Subject: ISSUANCE OF AMENDMENT (TAC 65639)

OYSTER CREEK NUCLEAR GENERATING STATION

Amendment No. 117
License No. DPR-16

SAFETY EVALUATION BY THE OFFICE OF NUCLEAR REACTOR REGULATION
SUPPORTING AMENDMENT NO.117 TO PROVISIONAL OPERATING LICENSE NO. DPR-16

FIGURE 6.2.1
ORGANIZATION CHART
GPU NUCLEAR CORPORATION

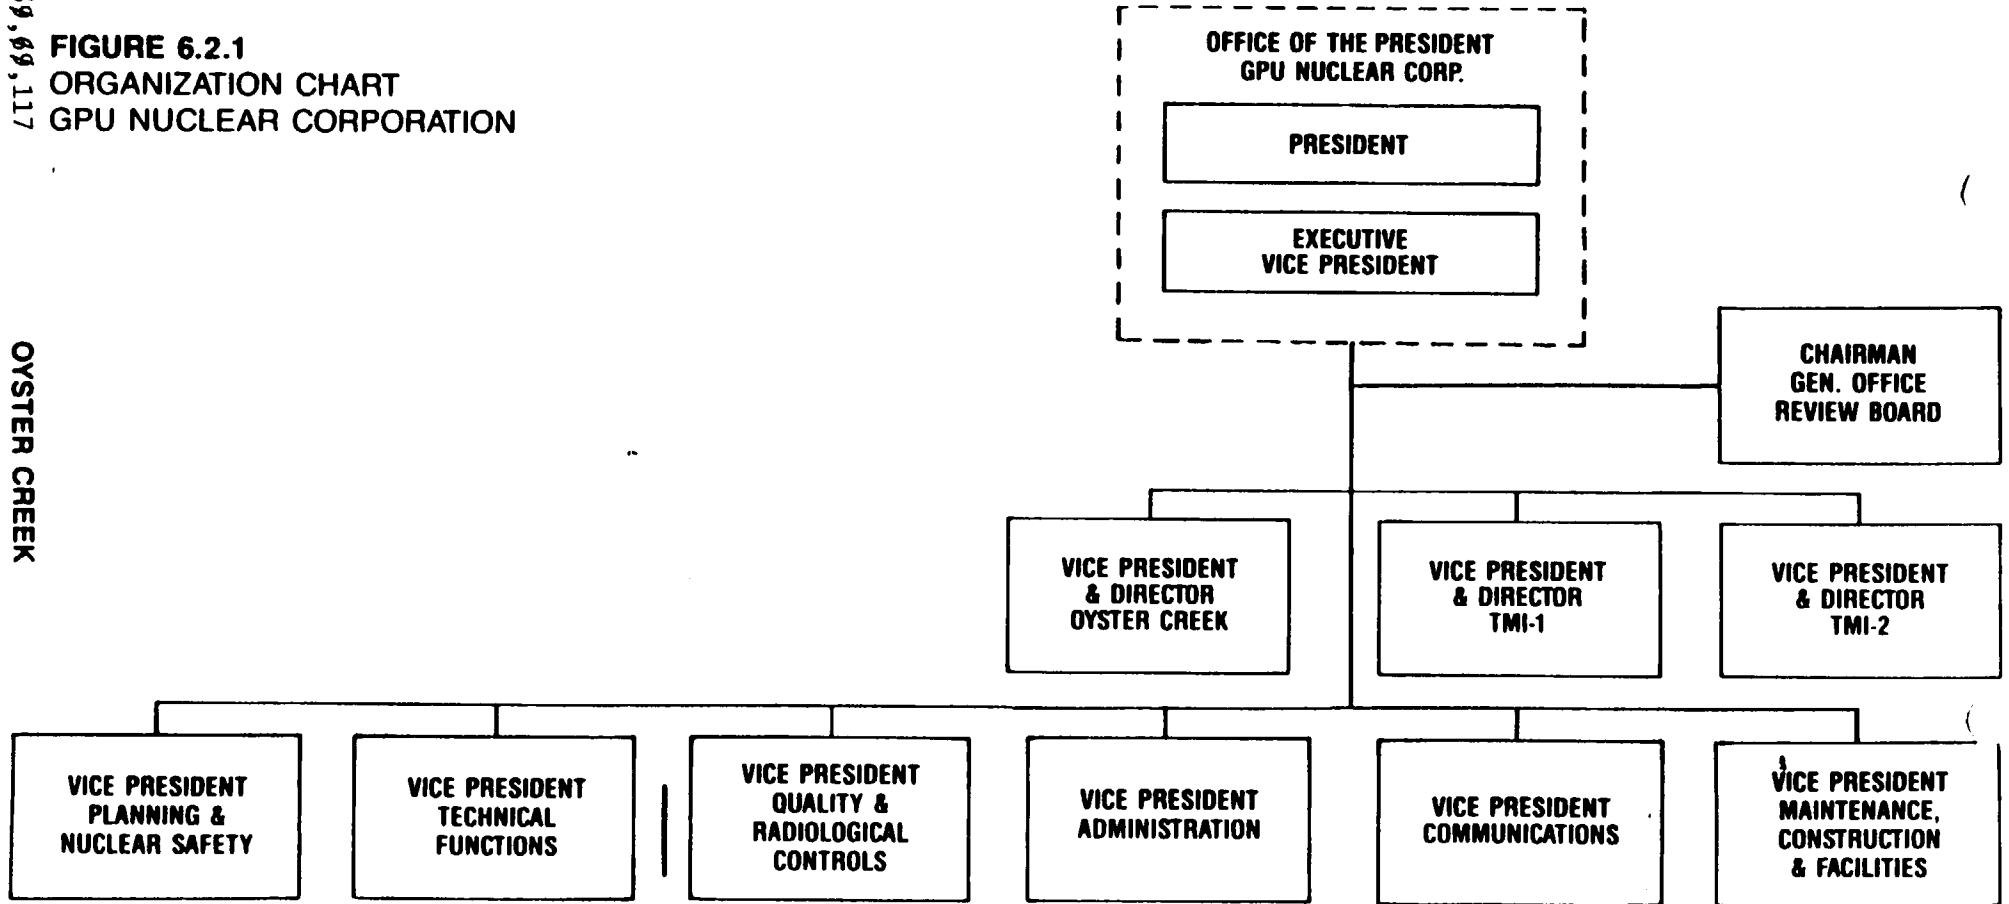
GPU Nuclear has revised the corporate structure by deleting the organizational divisions under the Vice President Nuclear Assurance and Vice President Radiological and Environmental Controls and creating organizational divisions under a Vice President Quality and Radiological Controls and Vice President Planning and Nuclear Safety.

The current responsibilities of the Vice President Radiological and Environmental Controls, and Vice President Nuclear Assurance have been transferred to the new position of Vice President Quality and Radiological Controls. The current responsibilities of Nuclear Safety Assessment have been transferred to the new position of Vice President Planning and Nuclear Safety; and the current responsibilities of the Director Training and Education have been transferred to the Vice President Administration. These changes are shown in revised Figure 6.2-1.

We have reviewed the requested changes and found them acceptable as they have not deleted any functional units that support the operation of Oyster Creek and the organization meets the acceptable criteria of Section 13.1.1 of NUREG-0800, the Standard Review Plan.

FIGURE 6.2.2
ONSITE ORGANIZATION

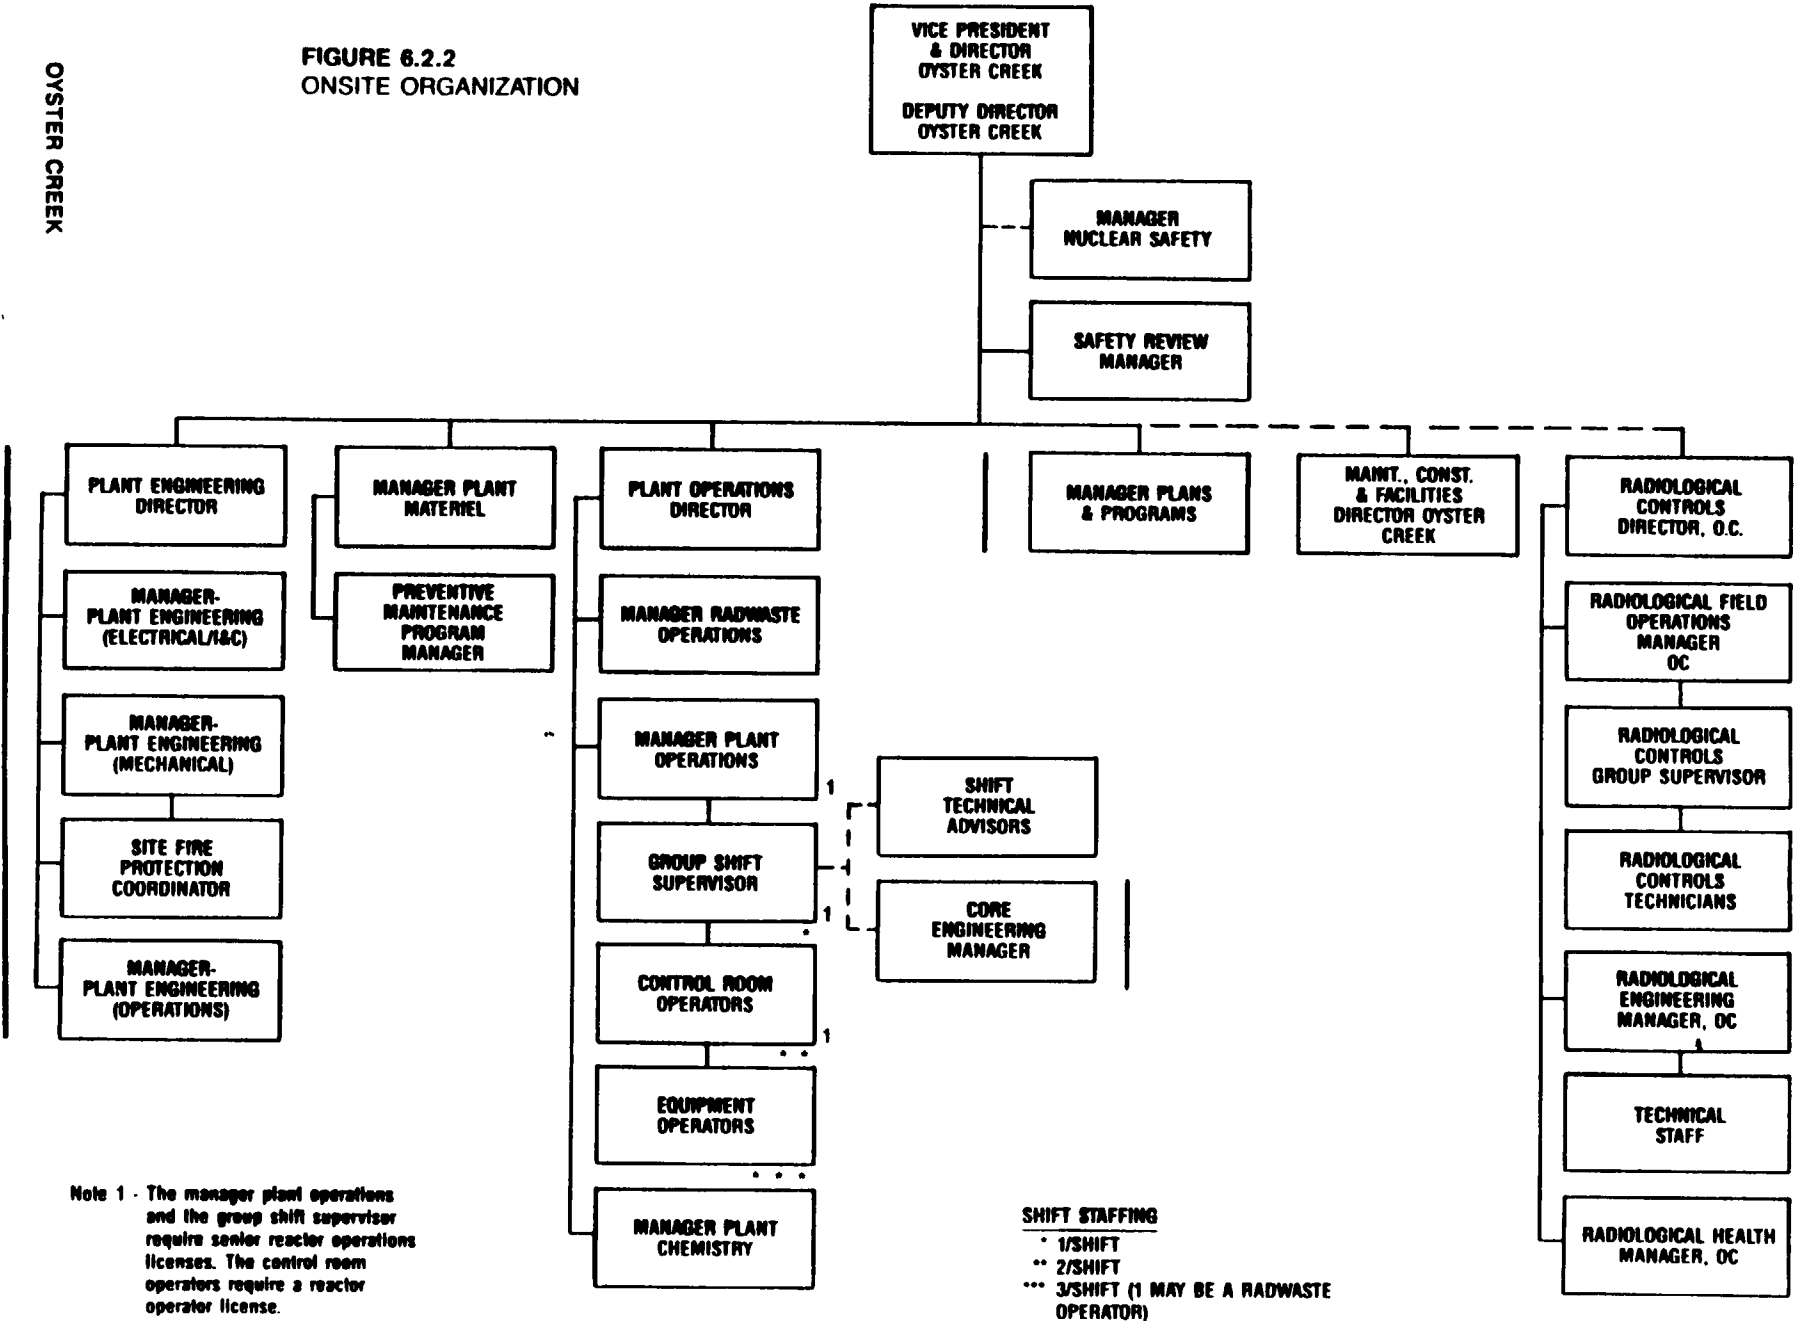
A. The following organization titles of the onsite organization have been changed.

- 1) Manager Plant Administration to Manager-Plans and Programs
- 2) Maintenance and Construction Director Oyster Creek to Maintenance, Construction, and Facilities Director-Oyster Creek
- 3) Operational Maintenance, PM and Surveillance Manager to Preventative Maintenance Program Manager
- 4) Radiological Support Manager, OC to Radiological Health Manager-OC
- 5) Manager Maintenance Engineering to Manager-Plant Engineering (Electrical/I&C)
- 6) Manager Support Engineering to Manager-Plant Engineering (Mechanical)
- 7) Manager Operations Engineering to Manager-Plant Engineering (Operations)
- 8) Core Manager to Core Engineering Manager

B. The position of Core Engineering Manager now reports to the Vice President Technical Functions rather than the former position of Manager Operations Engineering.

These changes are shown on revised Figure 6.2.2. We find these title changes acceptable as they are administrative changes only. The Core Engineering Manager change is a reassignment of function within the unit organization and is also administrative change.
